## ADDENDUM NO. 2

DATE: July 22, 2010

Contract: 08 - C-00021; Howard F. Curren AWTP Sludge Digester No. 6 Rehabilitation

HOWARD F. CURREN A.W.T.P.  
 SLUDGE DIGESTER No. 6 REHABILITATION  
 GENERAL, DEMOLITION & SLUDGE REMOVAL NOTES

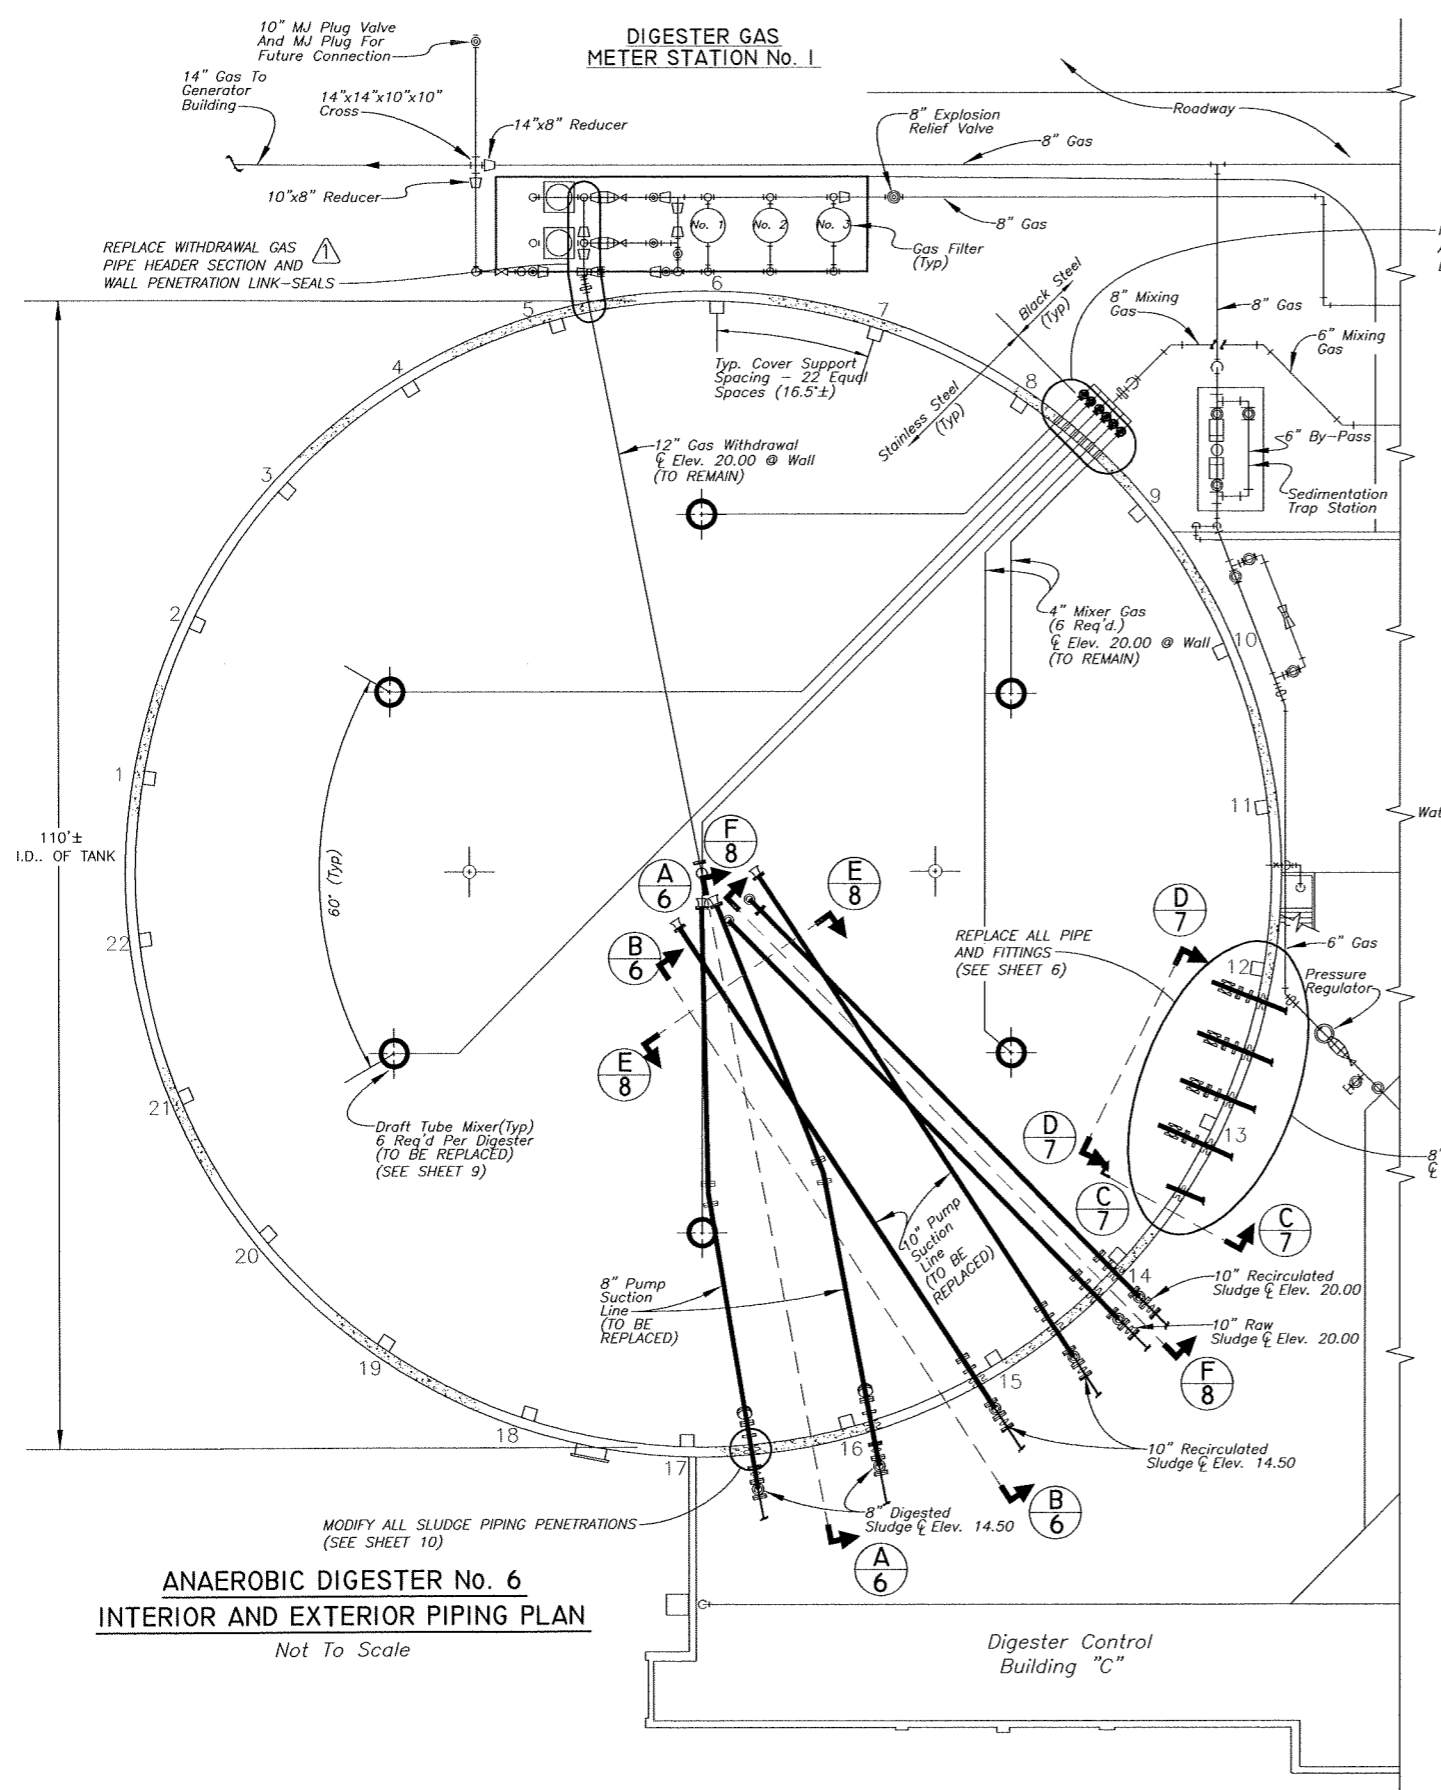
Response: The wall thickness of the proposed 36-inch diameter T304L stainless steel mixing tubes has been changed from Schedule 20 pipe (0.500" thickness) to Schedule 10 Pipe (0.312" thickness) with this Addendum. Note: A note was added to Sheet 3 of the plans regarding the mixing tubes with additional requirements if the tubes are to be made from rolled sheets.

No.	DATE	REVISIONS
3		
2		
⚠	07/21/10	REVISED NOTES, ADDED NOTES D-8, G-13, G-14

- ⚠ G-14. THE 36" DIAMETER STAINLESS STEEL GAS MIXING TUBES SHALL BE MADE OF EITHER EXTRUDED PIPE OR ROLLED SHEET. IF MADE FROM ROLLED SHEET THE TUBES SHALL BE OXYGEN-PURGED TIG-WELDED AND THEN BE RE-ROLLED TO TRUE ROUNDNESS. CONTRACTOR SHALL SUBMIT WELDING AND ROLLING PROCESS FOR APPROVAL.

HOWARD F. CURREN A.W.T.P.  
SLUDGE DIGESTER No. 6 REHABILITATION  
DIGESTER - PLAN AND ROOF PLAN

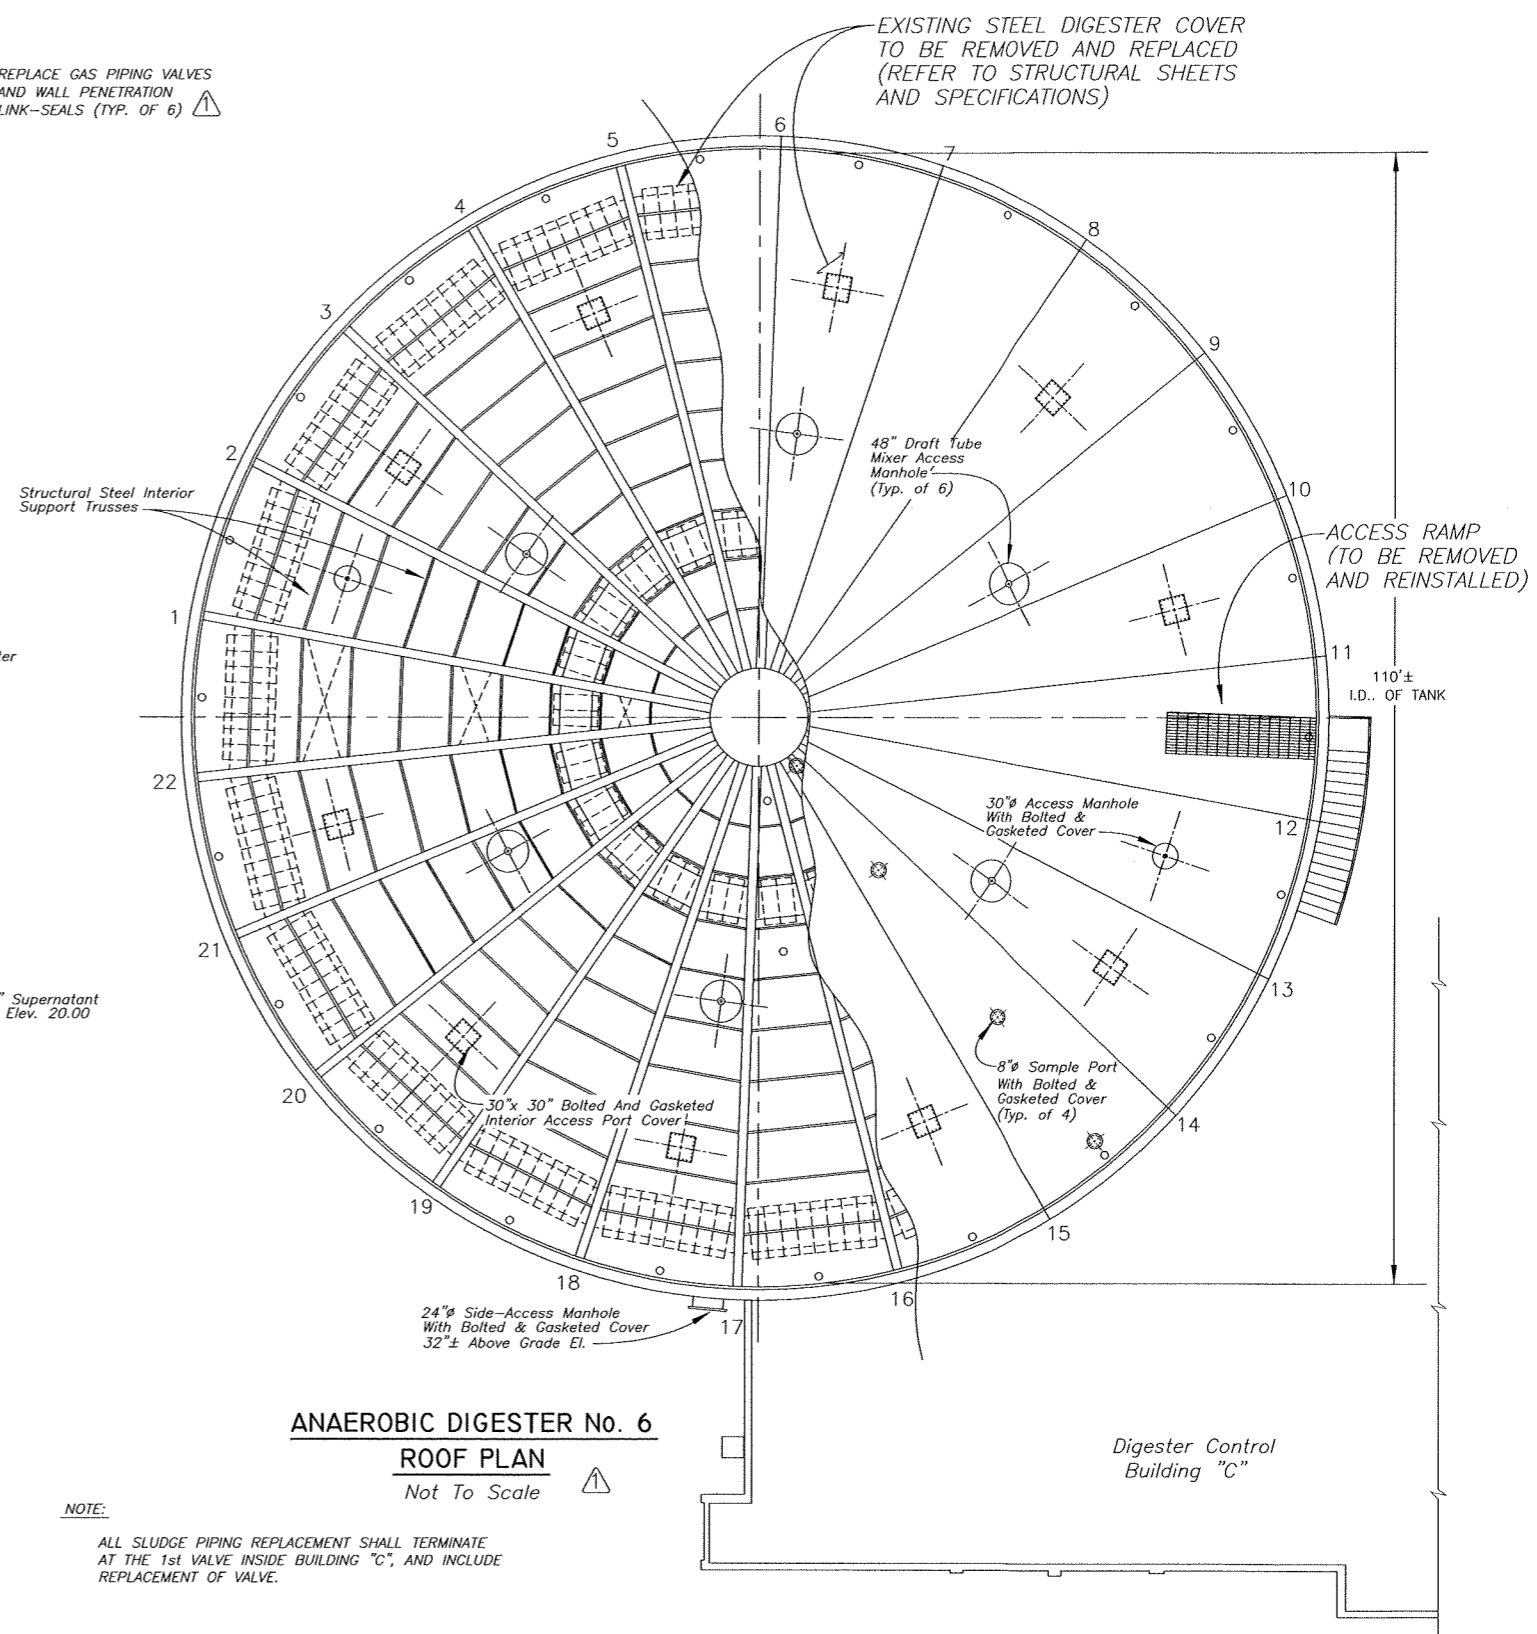
No.	DATE	REVISIONS
3		
2		
1	07/21/10	ADDED VALVES AND PIPING, REVISED ROOF PLAN

HOWARD F. CURREN A.W.T.P.  
 SLUDGE DIGESTER No. 6 REHABILITATION  
 MISCELLANEOUS GAS MIXER DETAILS

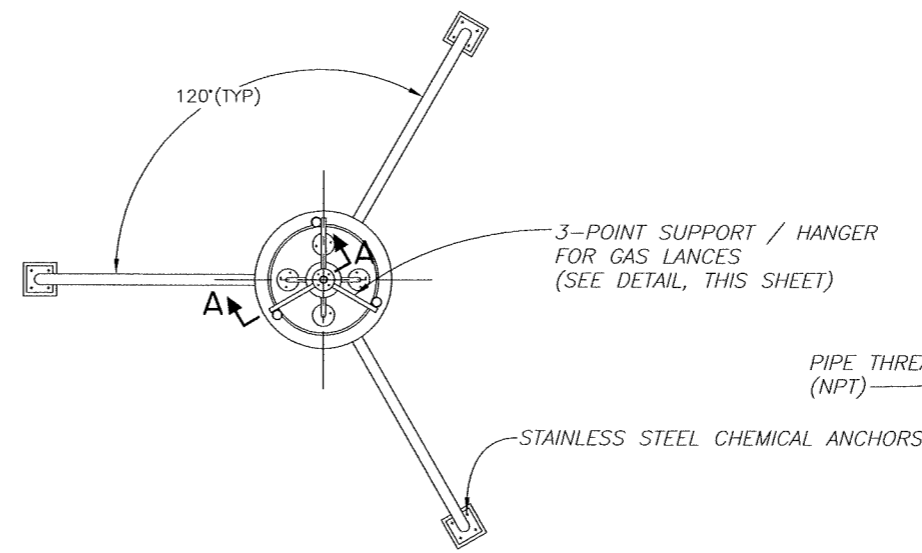
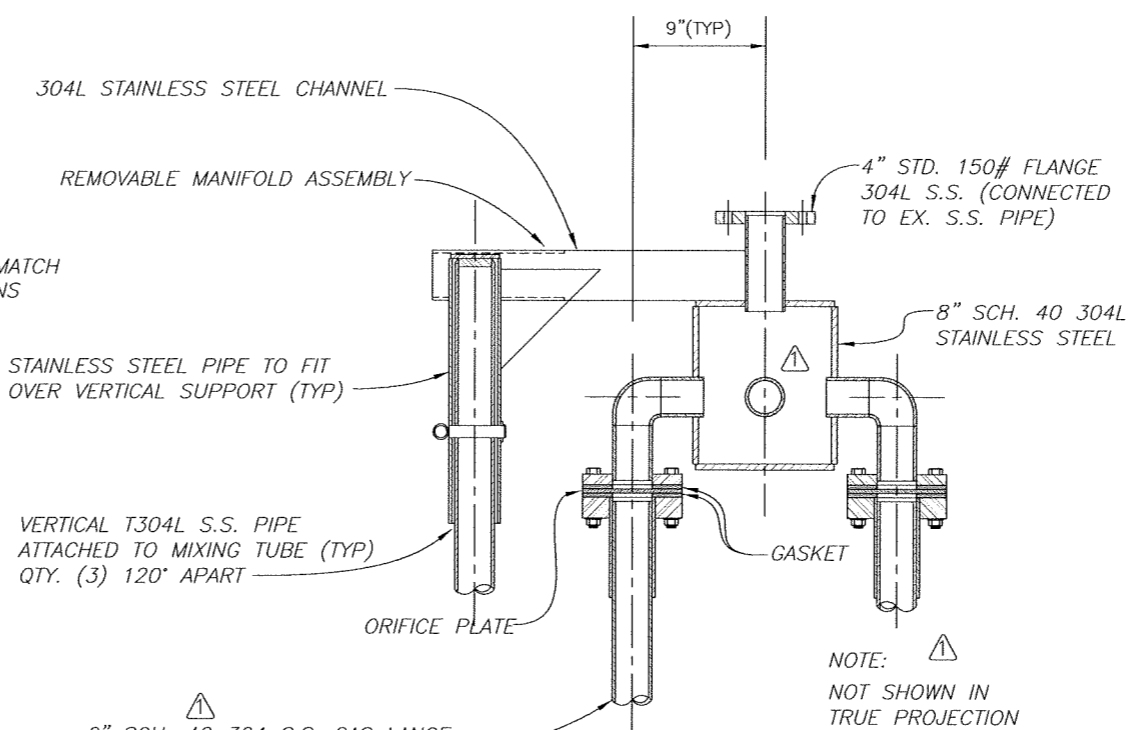
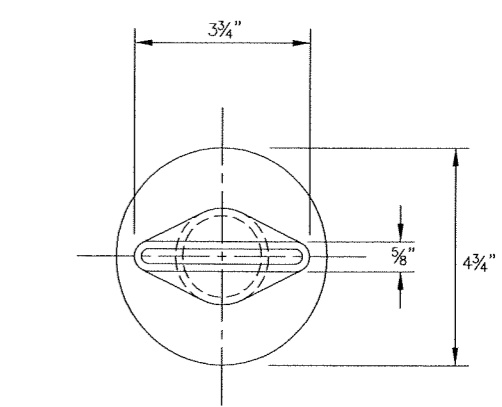
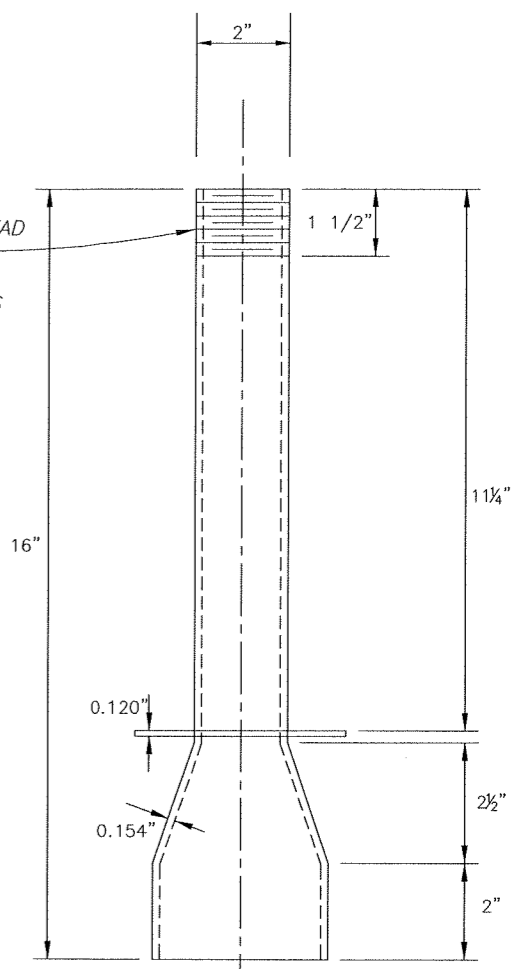
19. Question: The 36-inch diameter T304L stainless steel mixing tubes are specified to be Schedule 20 pipe. This is not available as pipe and will be very difficult to roll as steel plate. Can this be modified?

No.	DATE	REVISIONS
3		
2		
1	07/20/10	REVISIONS MADE TO DRAWING, PIPE THICKNESS

**DRAIN SUMP WITH ACCESS WELL DETAIL - SECTION VIEW**

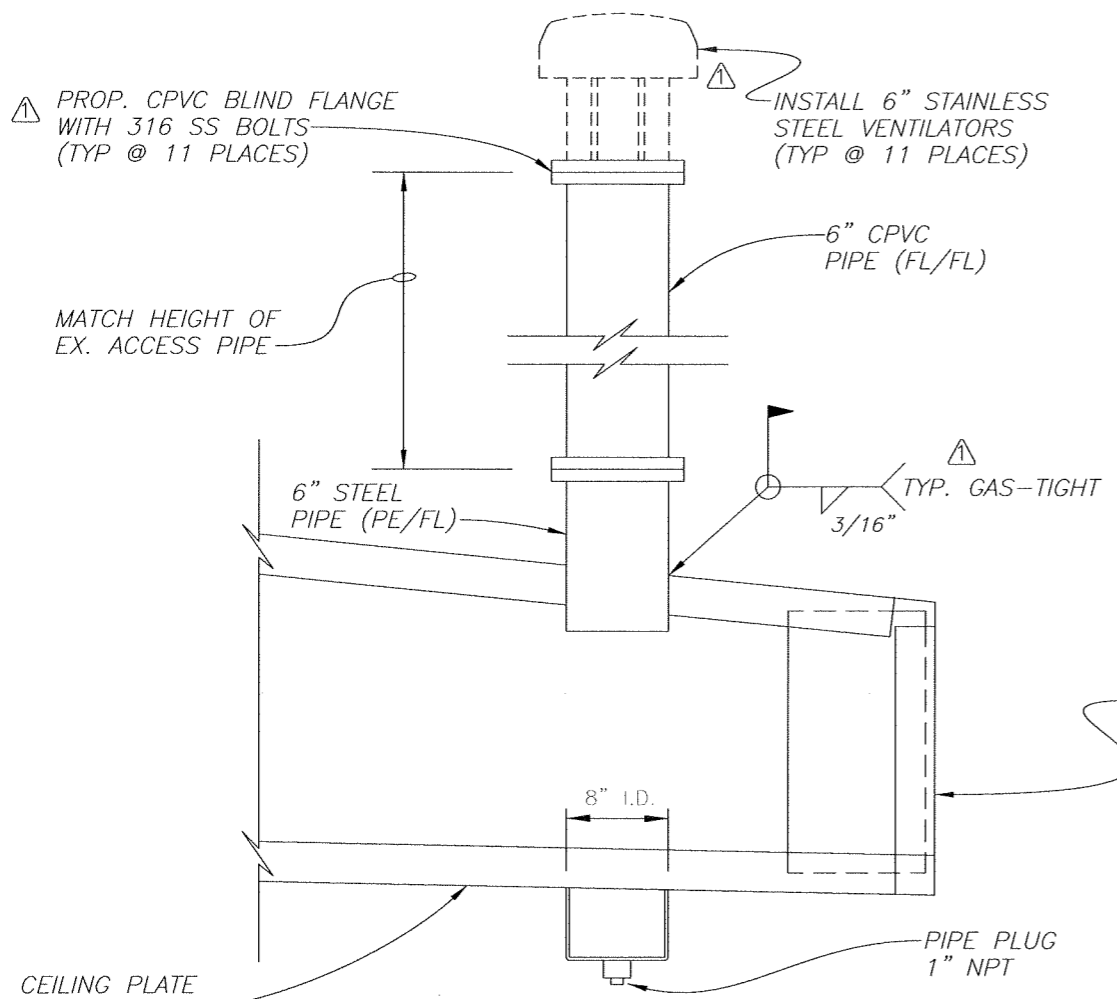
25. Question: A digester cover manufacturer proposes to provide pressure equalization units on each of the 30-inch square access covers. Will this be acceptable.

No.	DATE	REVISIONS
3		
2		
1	07/21/10	REVISED DRAIN SUMPS & VENTILATORS

Response: No, the planned ventilator units are designed to be at an elevation where they would not be submerged in situations where foam in the digester comes up and over the roof of the floating cover. This has been a problem in the past. Also, the outer 11 ventilators are planned to set over drain sumps in the outer periphery of the cover's ceiling.

**SAMPLING WELL DETAIL - SECTION VIEW**

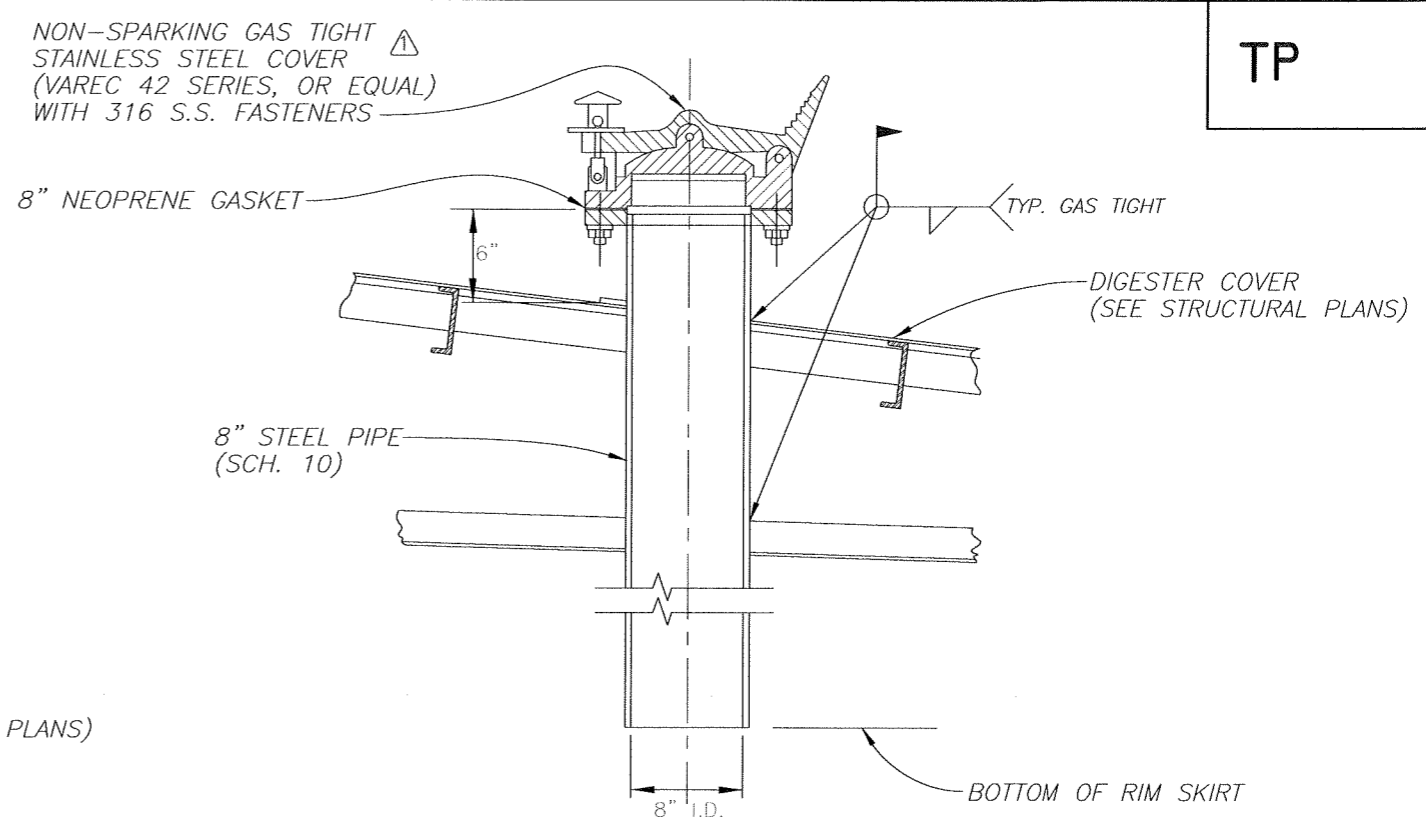
16. Question: Drawing on Plans sheet 12 calls for aluminum sample covers. However, the specifications (Section 13233.2.03.B) call for bronze. Please clarify.

- J. 4 - Sampling wells, 8"-Ø with quick opening non-sparking gas tight covers, gaskets, and stainless steel fasteners. Sampling pipes are 8" schedule 40 steel pipe. All wells to extend to the bottom of the rim skirt. The sampling hatches shall be non-sparking and shall be made of stainless steel.

Response: The four 8-inch sample covers specification has been changed with this Addendum and now calls for a specific make and model of non-sparking sample covers with stainless steel caps and bases.
